# Development Review Public Comment

LDC25-00003

Comments regarding Case Number LDC25-00003

2400 W 7<sup>th</sup> Street

**Figure 4-16: Parcel Size Matching**

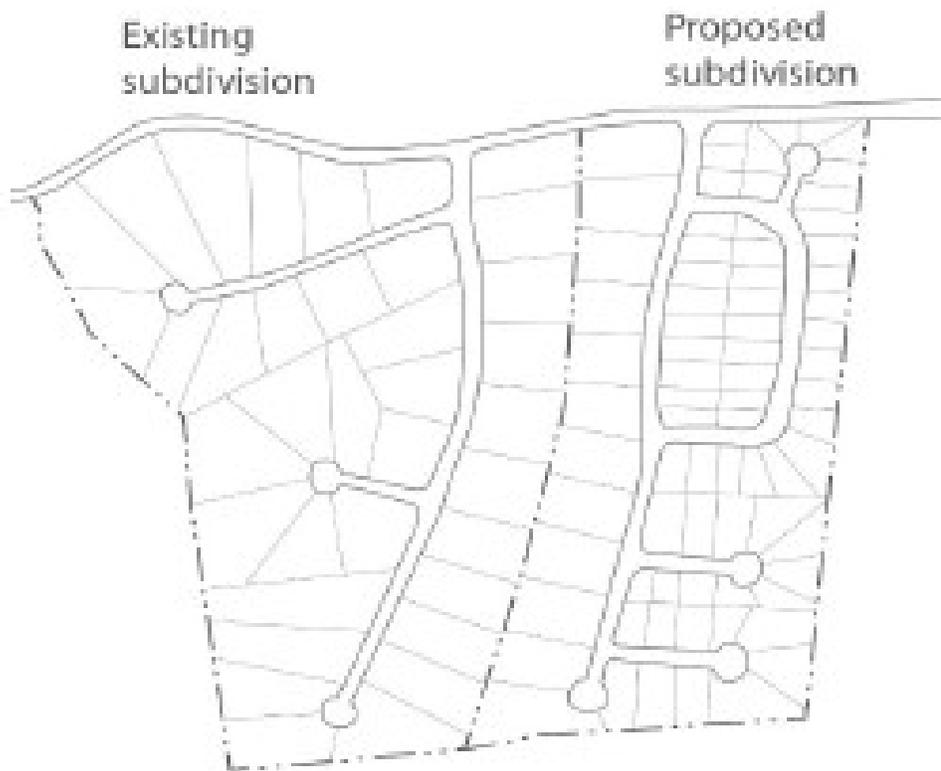
Parcel Size Matching states, “The minimum lot sizes identified in the land use designation of the immediately adjacent property shall be maintained at the edge of the proposed subdivision as depicted in Figure 4-16”

The Western boundary, shown in the Preliminary Lot and Block Plan, shows three different buffer widths. 23 feet, 17 feet then all the way down to 5 feet, between the property line of lot 11 and the neighboring development fence. The developer stated at the N.A.B they have a 37-foot buffer. They are measuring from the neighboring development fence line all the way to the physical home being built not the property line. Code shows that it is from the property line of the existing development to the property line of the proposed development, not structure to structure. The developer must draw new plans for the entire Western boundary creating a 30-foot buffer. This code is black and white there is no way around it.

**Figure 4-18: Yard Matching**

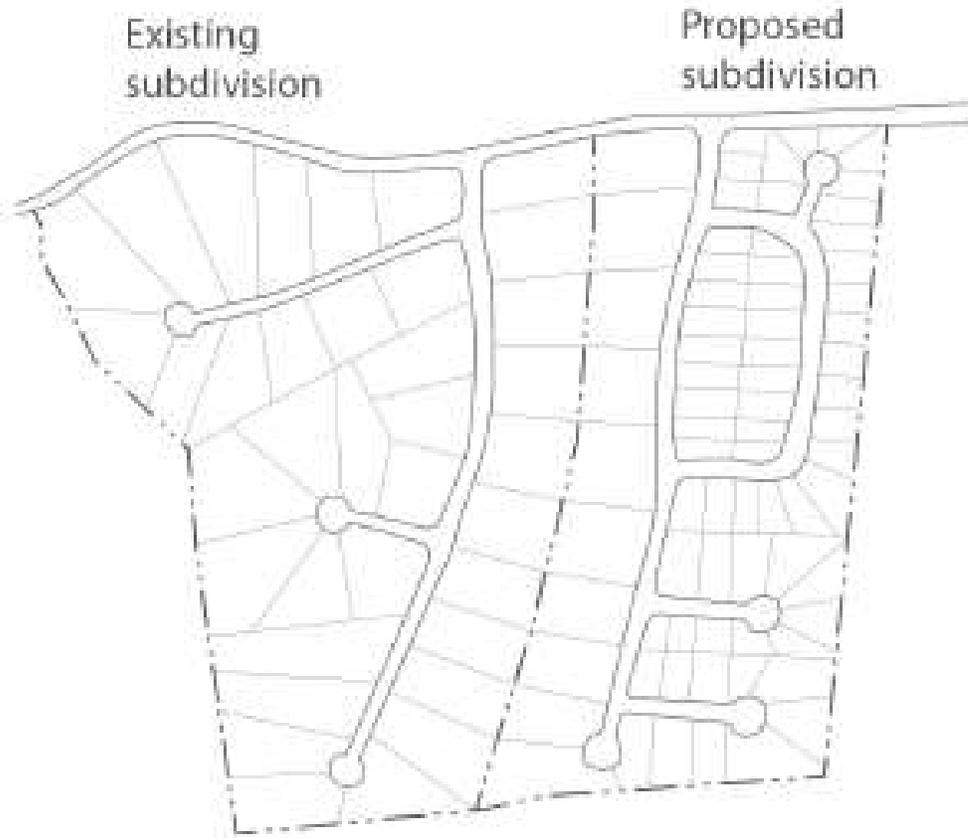
Yard Matching states “The rear yard widths of the proposed development shall match the rear yard widths of the existing development as depicted in Figure 4-18.”

There is no caveat for this code and buffering does not appear to apply. As the code reads the widths of the existing subdivision and proposed subdivision must match. The proposed subdivision rear yards are approximately half the size of the existing subdivision.

Wood Rodgers Elevation and Grading 2605 and 2615 Everett Dr

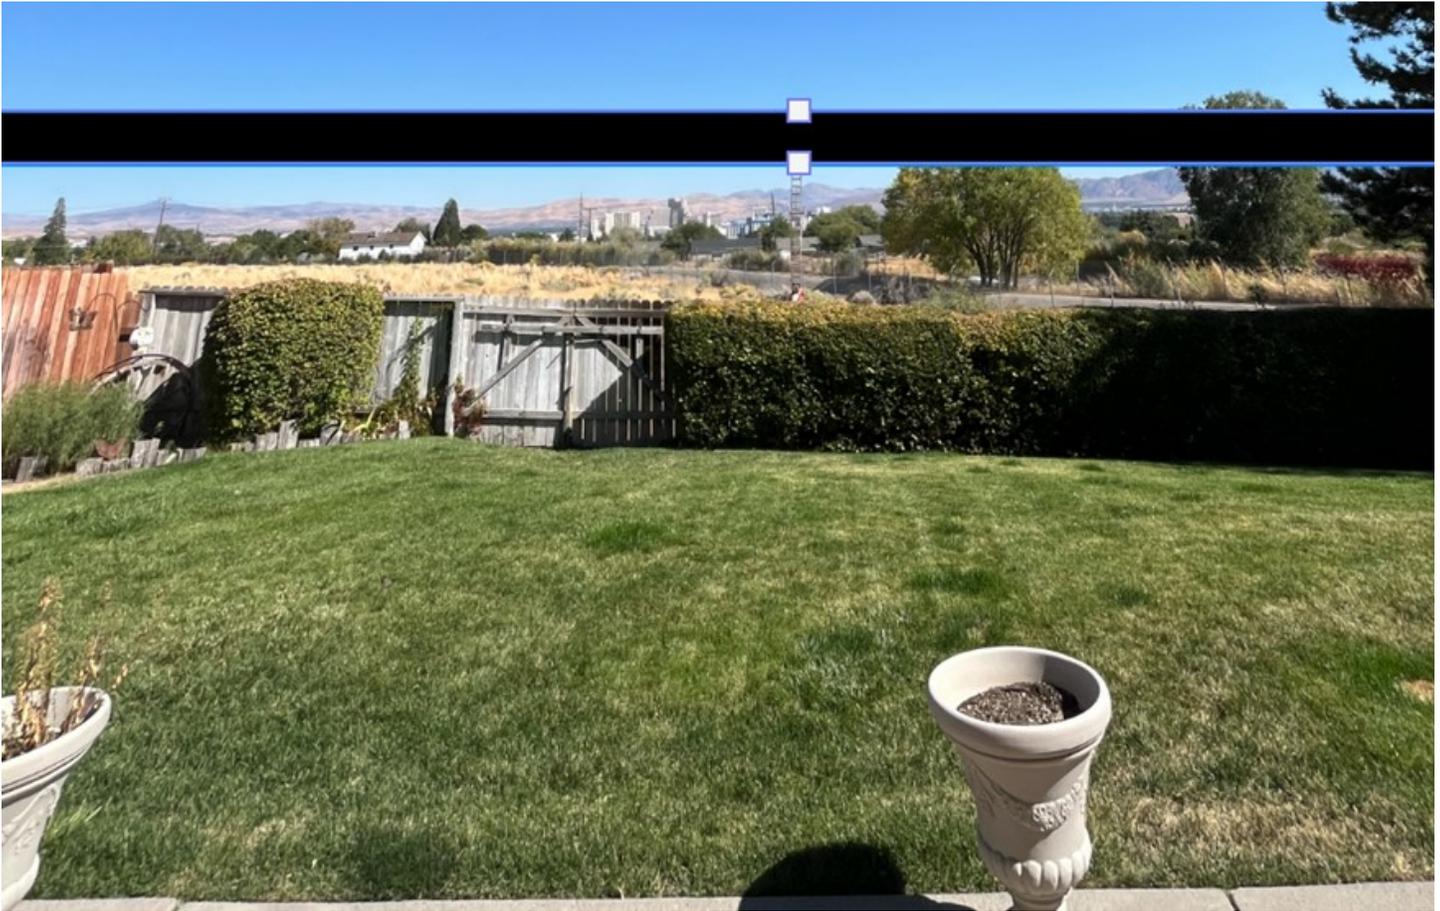
Initial grade plan showed a 6-foot elevation difference from 2605 to the eastern boundary. This document says there is a 9-foot elevation difference. I believe that would put home 14 below the grade of the Highland ditch. Don't think that's possible.

Even if this grade is accurate, (figure 2) homes A, B, D and E would have to stand on their roofs to see over adjacent homes. This is not protecting views.

Pictures of where rooflines will approximately fall. Homes on SE boundary do not allow views between houses due to 45 degree offset.

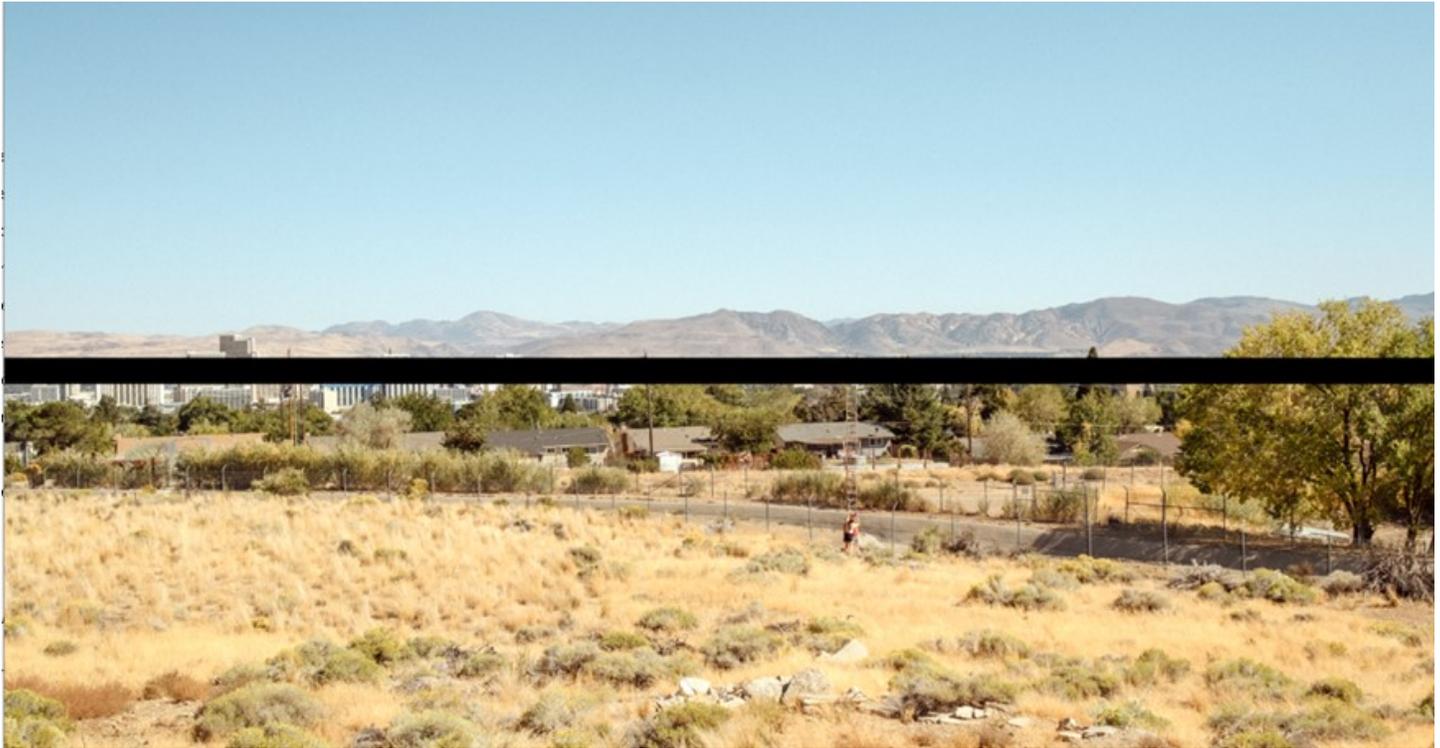
2615 view from back patio to estimated height of home 13 (point E). 28' roofline. From highland ditch grade/base elevation. (Home 11 will be much more obtrusive due to closer proximity.)

2605 Everett view from 2nd story deck to estimated height of home 14. 28' roofline. From highland ditch grade/base elevation.

Proposed homes will need to sit slightly higher than base grade level to allow for drainage away from home. Rooflines will sit slightly higher than pictured above.
